Access Compliance Report

Public Rights-of-Way

(Curb Ramps)

Intersection ID: 10749	Main Street: ALLEGHANY_ST	Cross Street: FREEDOM_DR	Location: S
ADA ID: 0FE68D3055A8	Ramp Type: Perp	Initial Pass/Fail: Fail	Overall Compliance: No
Severity Score: 8.75			
Codes/Mitigation Info/Possible Solution		Field Measurements/Component Compliance

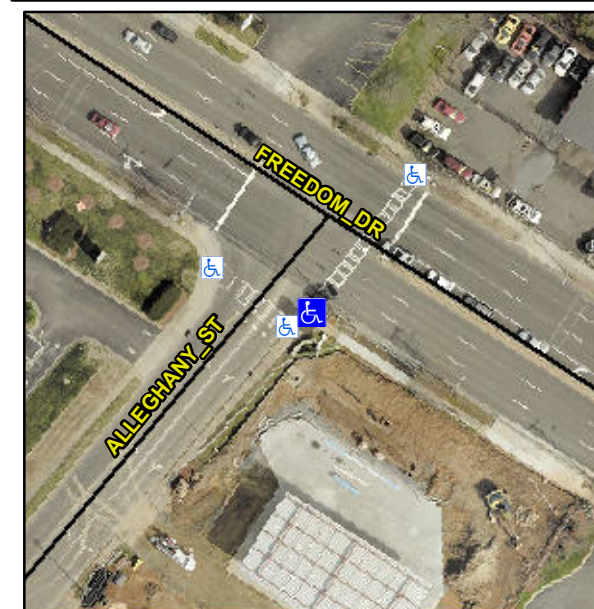
Not Found, R304.5.1

Compliance	Description	Data	Compliance	Description	Data
N/A	Ramp Length (in)	90.0	Yes	Ramp Slope (%)	5.0
No	Ramp Width (in)	47.5	Yes	Ramp XSlope (%)	2.0
N/A	Flare Type LT	N/A	N/A	Flare Type RT	N/A
N/A	Flare Slope LT (%)	N/A	N/A	Flare Slope RT (%)	N/A
N/A	Flare Traversable LT?	N/A	N/A	Flare Traversable RT?	N/A
N/A	Landing Length (in)	N/A	N/A	DWS Provided?	N/A
N/A	Landing Width (in)	N/A	N/A	DWS Contrast?	N/A
N/A	Landing Slope (%)	N/A	N/A	DWS Length (in)	N/A
N/A	Landing X Slope (%)	N/A	N/A	DWS Full Width?	N/A
N/A	Landing Curb? (Y/N)	N/A	N/A	DWS Offset (in)	N/A
N/A	Shared Landing?	N/A			
N/A	Gutter Ponding?	N/A	N/A	Gutter Slope (%)	N/A
N/A	Gutter Lip Ht (in)	N/A	N/A	Gutter X Slope (%)	N/A
N/A	Painted X Walk1?	Yes	N/A	Painted X Walk2?	N/A
	X Walk 1 Direction	To NE		X Walk 2 Direction	N/A
N/A	X Walk 1 Width (in)	69.0	N/A	X Walk 2 Width (in)	N/A
	X Walk 1 Slope (%)	2.1		X Walk 2 Slope (%)	N/A
	X Walk 1 X Slope (%)	2.9		X Walk 2 X Slope (%)	N/A

Remove & Replace Entire Ramp.
